## Memorandum

**To:** Jim Totten, General Manager  
Lost Pines Groundwater Conservation District

**Subject:** Review of Manville Tonka Application Packet

Figure 1. Location of proposed Manville wells.

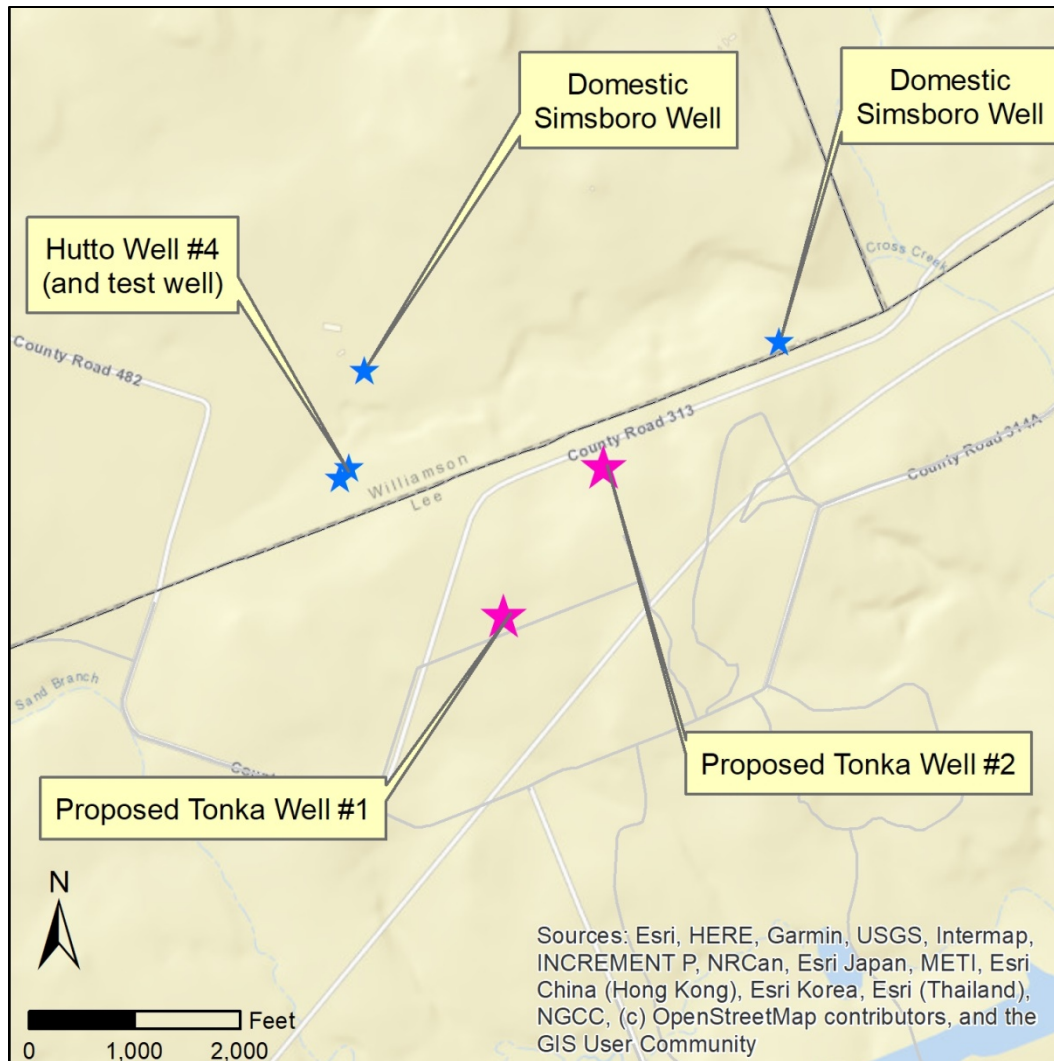
DBS&A has reviewed the operating permit application packet submitted by Manville Water Supply Corporation (Manville) for two wells to be completed in the Hooper Aquifer in Lee County. The proposed well locations are very near the Lee County-Williamson County line, as shown in Figure 1 below.

The proposed Manville wells will be approximately 700 feet deep and are not located near any other existing registered Hooper Aquifer wells within the District. These wells are located within approximately 2,500 feet of an existing Hooper Aquifer well in Williamson County that is owned and operated by the City of Hutto (Figure 1). There are currently no District spacing rules for wells in the Hooper Aquifer.

Figure 2. Project-specific 50-year drawdown (in feet) in the Hooper Aquifer attributable to the proposed Manville pumpage estimated using the updated GAM.

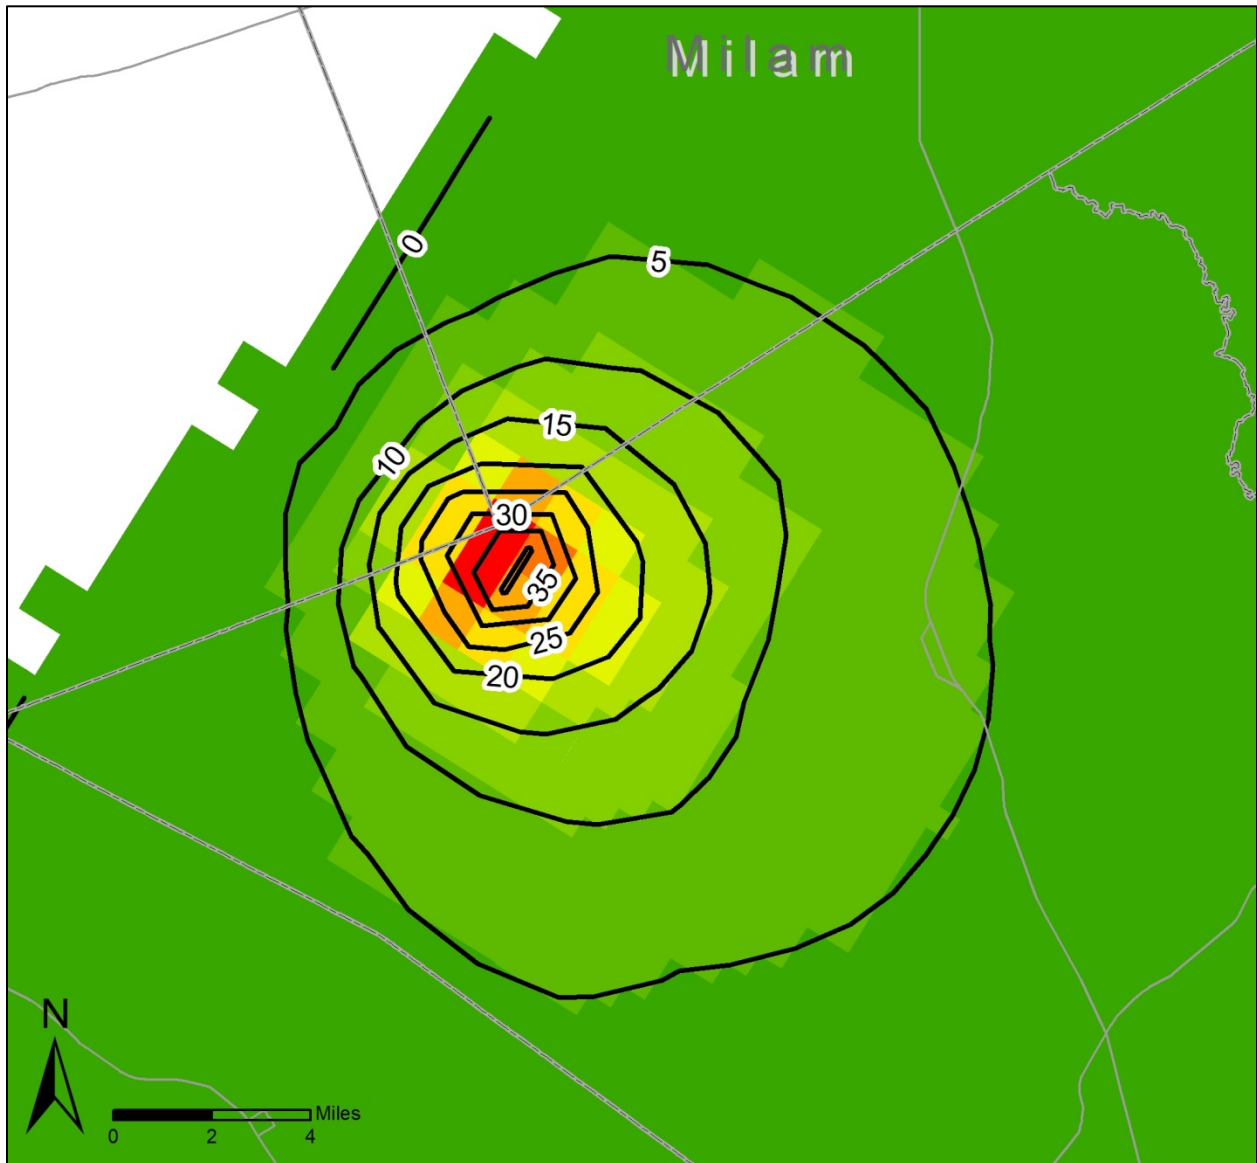
The updated Central Queen City-Sparta Groundwater Availability Model (GAM) was run with the proposed pumpage added in the nodes in which the proposed wells are located. A map of project-specific drawdown only estimated using the GAM is shown in Figure 2. The model run results indicate that at the end of 50 years of pumping (2070), the maximum project-specific drawdown is approximately 50 feet. The closest well to the proposed wells is located in Williamson County, and the predicted project-specific drawdown at this well is between 25 and 30 feet after 50 years of pumping.

These drawdown estimates are an approximation obtained using the regional-scale GAM, which may not account for local hydrogeologic conditions. However, it is reasonable to conclude that the pumpage from the proposed Manville wells will result in several tens of feet of drawdown in the immediate area near the proposed well locations. However, the estimated drawdown is predicted to decrease significantly at distance from the wells. This model run was completed in the same manner as previous model runs conducted to evaluate permit evaluations requested by the Board, but this evaluation was completed using the updated GAM.
